International Conference on Case Histories in Geotechnical Engineering (1993) - Third International Conference on Case Histories in Geotechnical Engineering

## Discussions and Replies Session 1

# DISCUSSIONS AND REPLIES

## SESSION I

Figure 4. Load vs. Deflection, Shafts 1-4.

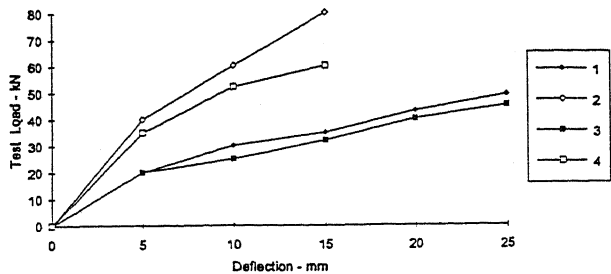
Although the shape of the load-deflection curves obtained from the in situ tests do match the actual load-deflection curves rather well (Figure 3), the question of why a shaft with a diameter of 0.51 m showed greater resistance than a similar length shaft of 0.61 m diameter does not appear to have been sufficiently scrutinized, the difference in observed performance being attributed to natural soil variations. Figure 4, based on the load test data of Figure 3, indicates clearly that the load-deflection behaviour is shaft length dependent. The almost identical behaviour of Shafts 1 and 3 (1.52 m length)

suggests that even with a 20 per cent difference in shaft diameter (0.51 m vs. 0.61 m) there is little difference in performance.

The question as to why the 0.51 m diameter pile (Shaft 2) performed better than the 0.61 m diameter pile (Shaft 4), when both are of the same length (2.44 m), needs to be answered. Figure 5 shows the relationship of the L/D ratio for the four test piles versus the load at 10 and 15 mm deflections at the pile head. Clearly, there is a trend for the lateral load capacity of these shafts to increase with the L/D ratio. It would therefore be interesting to see these tests extended to larger L/D ratios, while ensuring the shafts remain within the desiccated zone.
